## Section 2.9 Water Resources

**COSUMNES POWER PLANT  
DATA ADEQUACY RESPONSES (01-AFC-19)**

**FIGURE 2.2-6aR**  
**PHASE I - ANNUAL AVERAGE**  
**WATER BALANCE DIAGRAM**  
COSUMNES POWER PLANT  
APPLICATION FOR CERTIFICATION

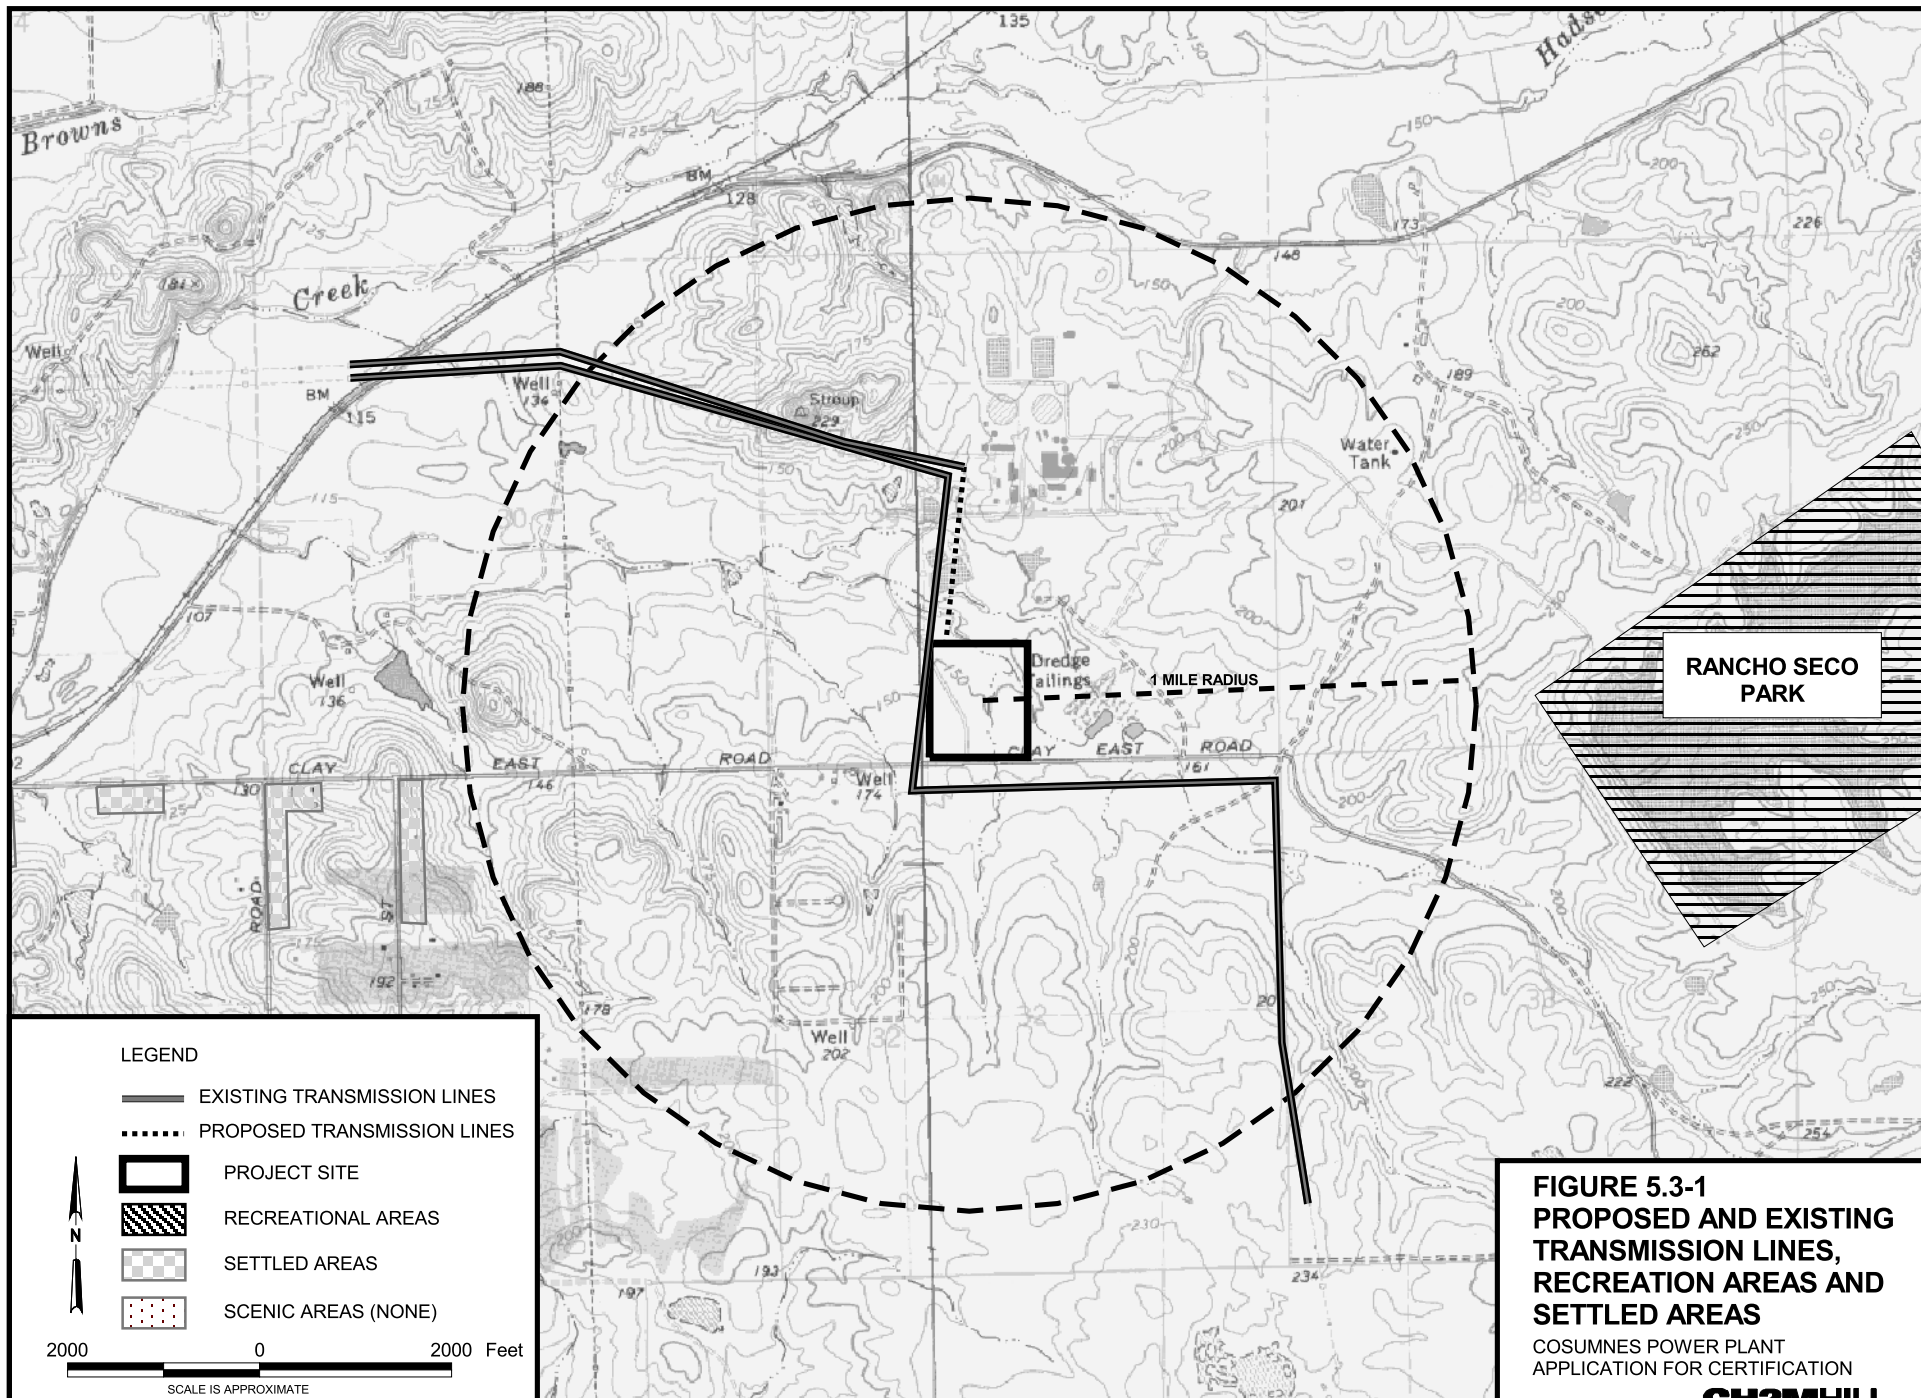
There is an internal inconsistency in the AFC with respect to disposal of cleaning wash water, which is corrected in the provided replacement pages (Figure 2.2-6aR, replacing Figure 2.2-6a; and Figures 8.14-3aR and 3cR, replacing Figures 8.14-3a and 3c). As indicated above, cleaning wash water is directed to the oily water separator, and then to the clarifier.

**FIGURE 8.14-6a**  
**PHASE I – ANNUAL AVERAGE**  
**WATER BALANCE DIAGRAM**  
COSUMNES POWER PLANT  
APPLICATION FOR CERTIFICATION

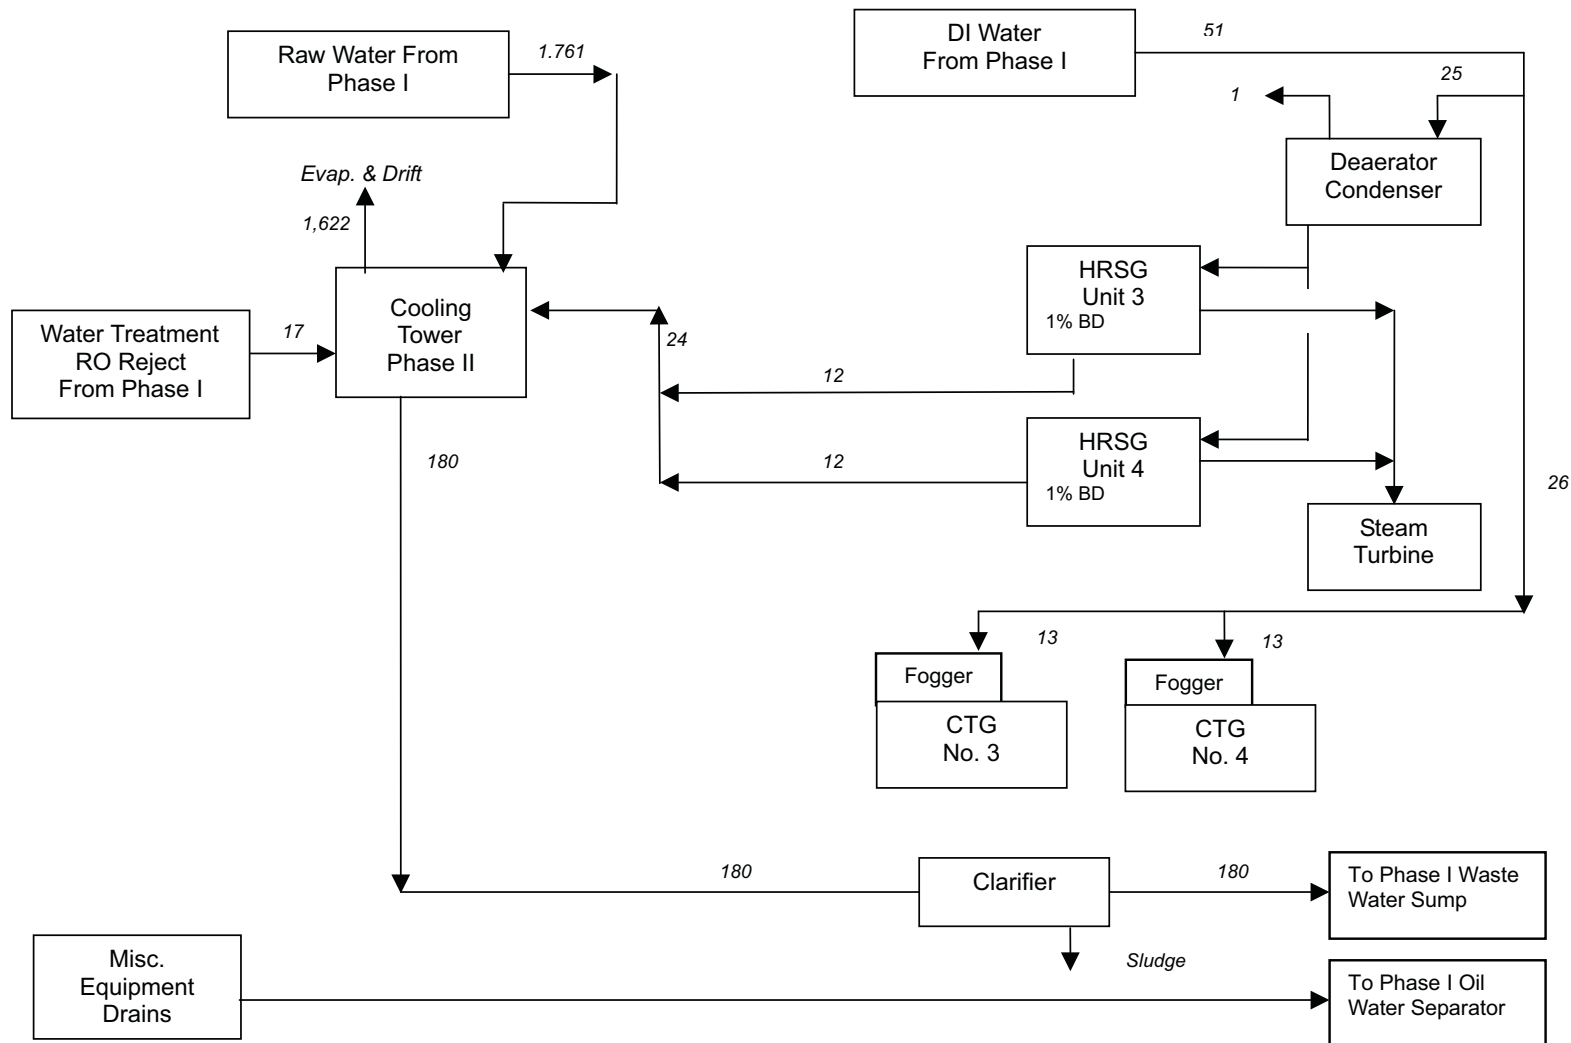
**WR-5: Data Adequacy Deficiency** – Please provide all information required by the regional board for a report of waste discharge, including appropriate maps at a 1:24,000 scale, or explain why this information is not needed.

- 1) Average and maximum daily water balance diagrams at 10 cycles of concentration.
- 2) A USGS 7½ Quadrangle map (or its equivalent) extending to at least one mile beyond site boundaries. The map must show the outline of the CPP, the location of each of its existing and proposed intake and discharge structures, each of its hazardous waste treatment, storage or disposal facilities. Include all springs, rivers, creeks and other surface water bodies, all domestic and irrigation wells, the direction of prevailing winds, and all residences in the map area.

**Average and Maximum Water Balance with 10 Cycles of Concentration:** There is a direct relationship between cycles of concentration, the quantity of water use and the concentration of discharge constituents. In Table 2.2-1, average and peak water requirements are provided for 3 cycles of concentration, which represent the maximum water use. In Table 8.14-3, concentrations of discharge constituents are conservatively estimated based on 10 cycles of concentration. In each case, the Applicant has provided the highest anticipated water use or highest concentration conditions. The water use for 10 cycles of concentration would be less than that provided in Table 2.2-1. We believe it was the intent of CEC staff to identify the “worst-case” condition, which is provided in the AFC. Actual operations of the plant would vary between 3 and 10 cycles depending on the discharge requirements issued by the RWQCB. The RWQCB has not yet determined the criteria, and therefore, the Applicant cannot predict whether the plant will be allowed to operate at 10 or 3 cycles of concentration, or somewhere in between. However, a water balance diagram at 10 cycles of concentration is presented as Figures 8.14-6a through 6d (attached).

**FIGURE 8.14-8c**  
**FLOOD ZONE MAP**  
COSUMNES POWER PLANT  
APPLICATION FOR CERTIFICATION  
**CH2MHILL**

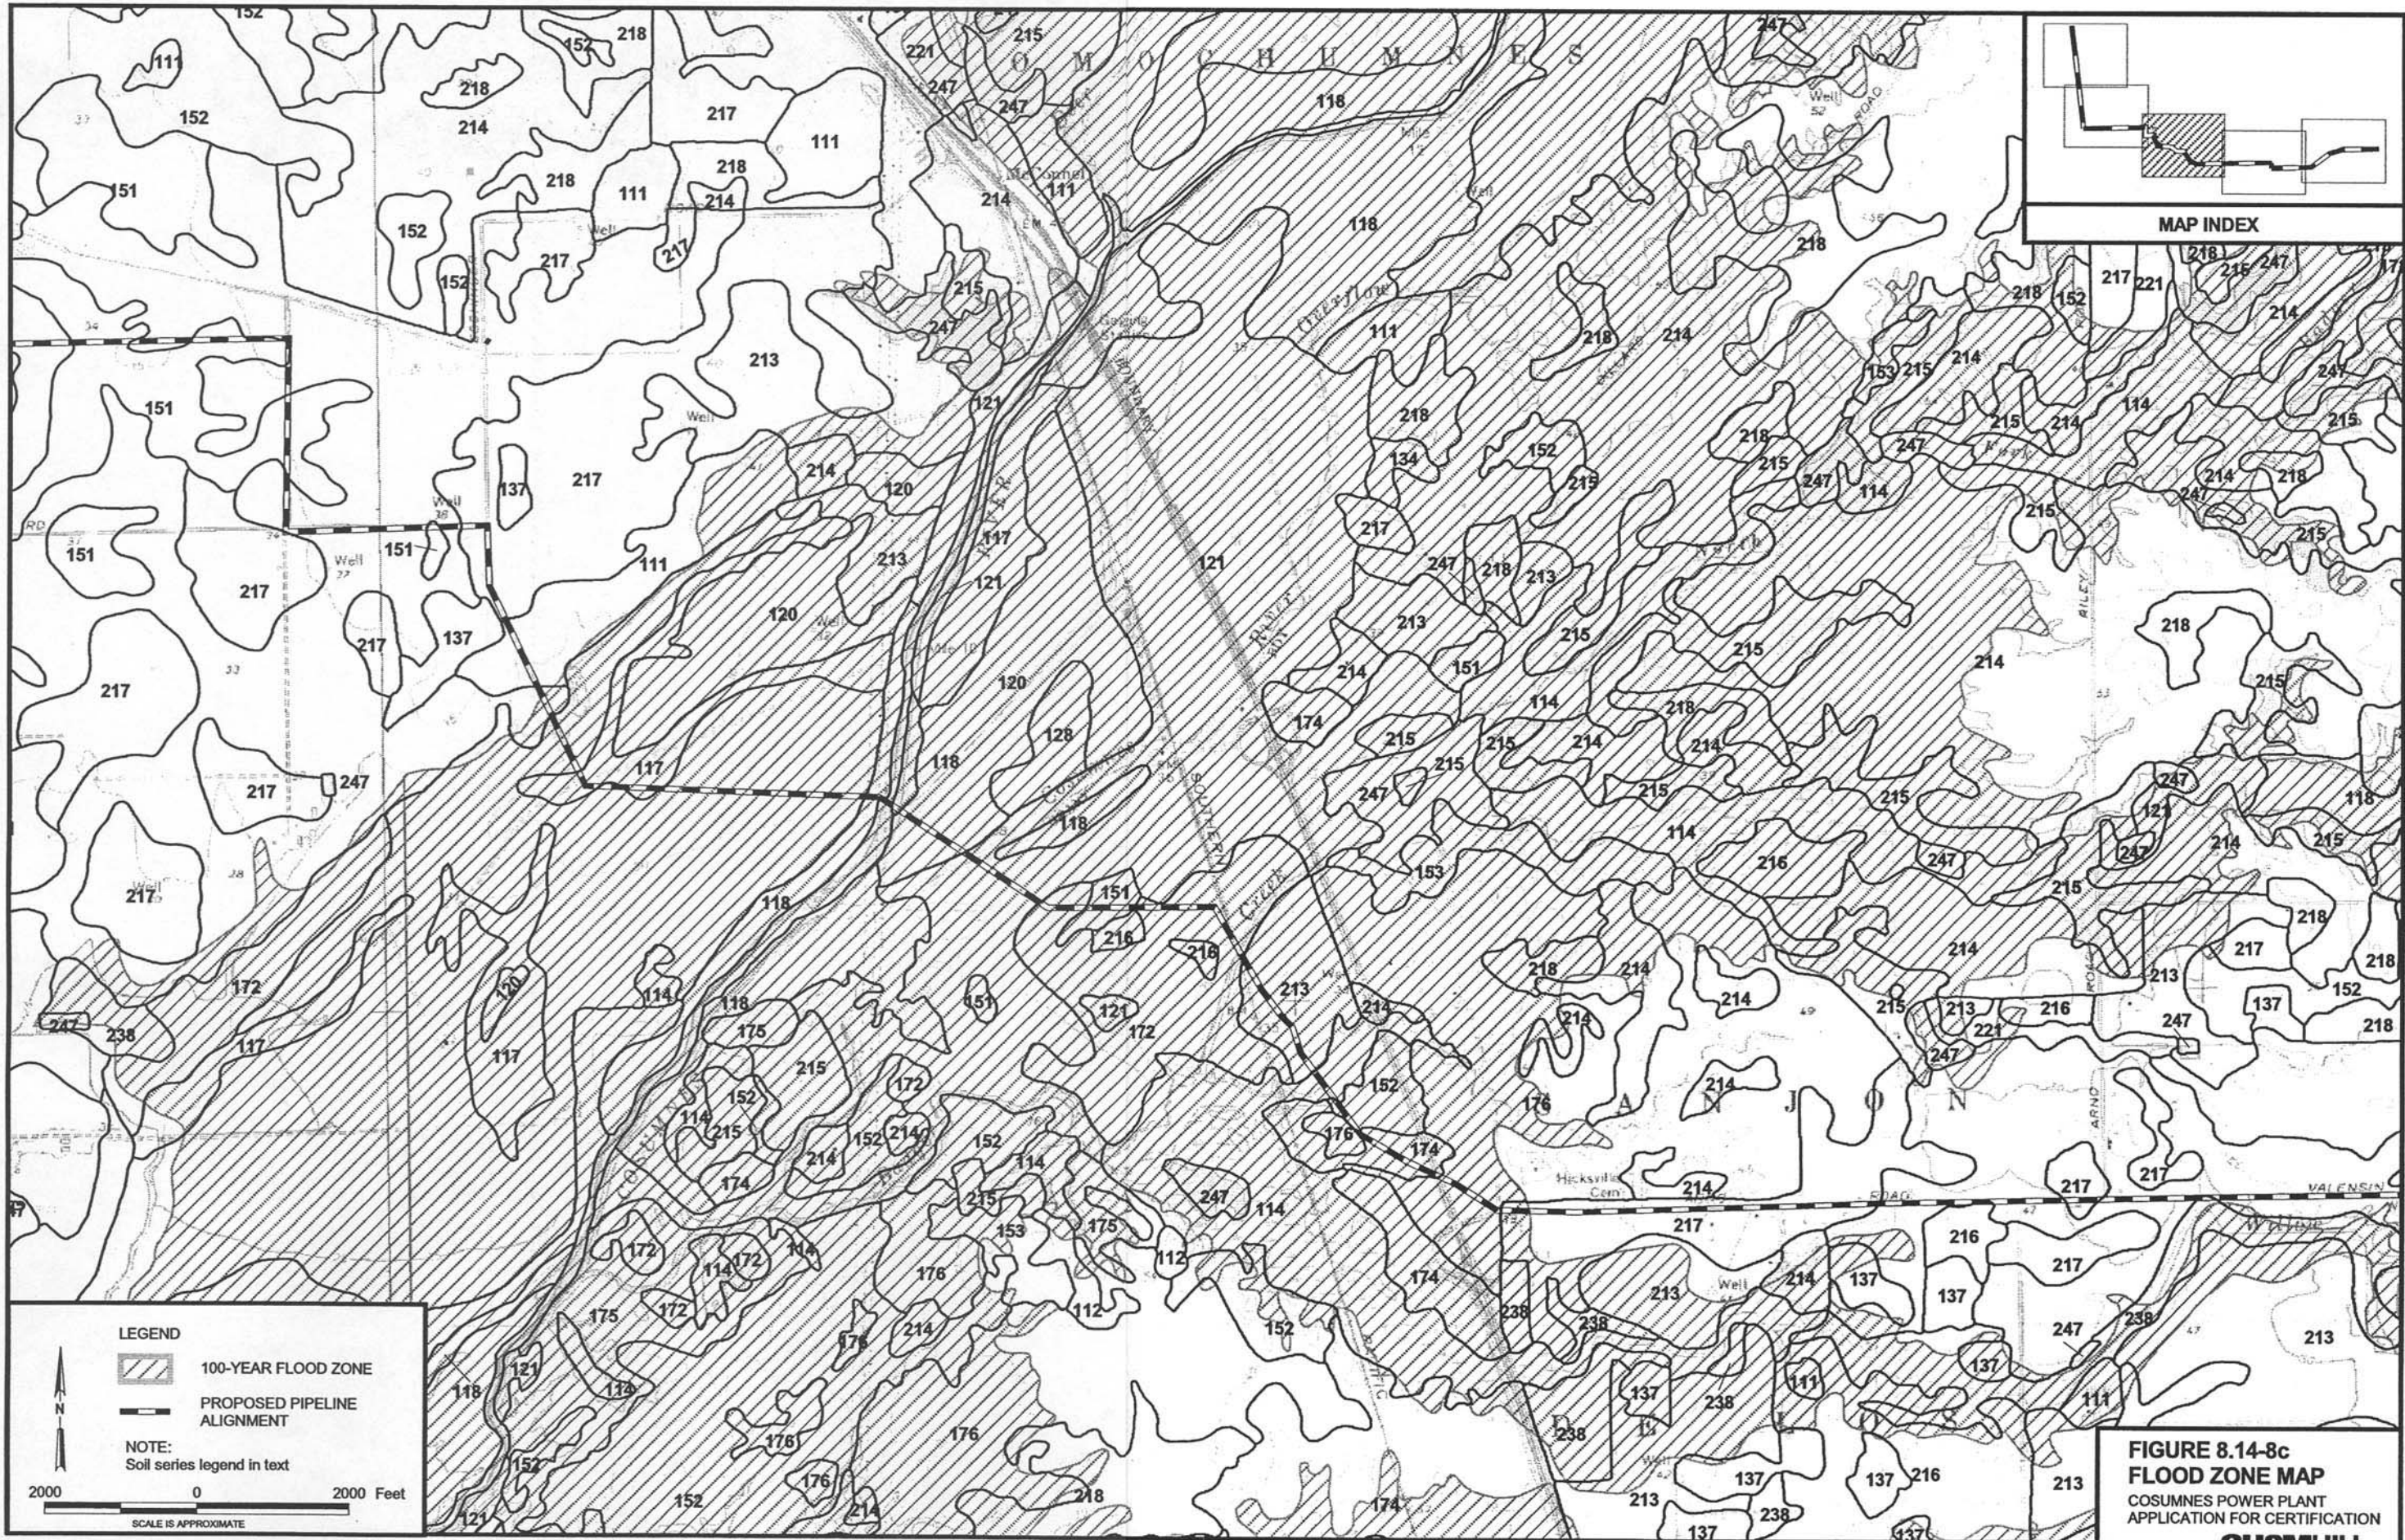
**WR-9: Data Adequacy Deficiency** – Please provide maps of water inundation zones at a scale of 1:24,000 that show both the project site and the route of the proposed gas pipeline.

**WR-19: Data Adequacy Deficiency** – More information is required on those areas of the 100-year flood plain where the proposed gas pipeline will cross and its potential effects on stormwater runoff.

**Data Adequacy Response** –Maps showing the flood plain overlain on the soils maps are attached as Figures 8.14-8a through 8e.

**Data Adequacy Response** – Figures 8.14-8a through 8e show the location of the 100-year floodplain relative to the proposed gas pipeline. The District believes that because the pipeline will be below grade and will result in no obstruction or displacement of flood capacity that the gas pipeline will have no affect on the 100-year floodplain.
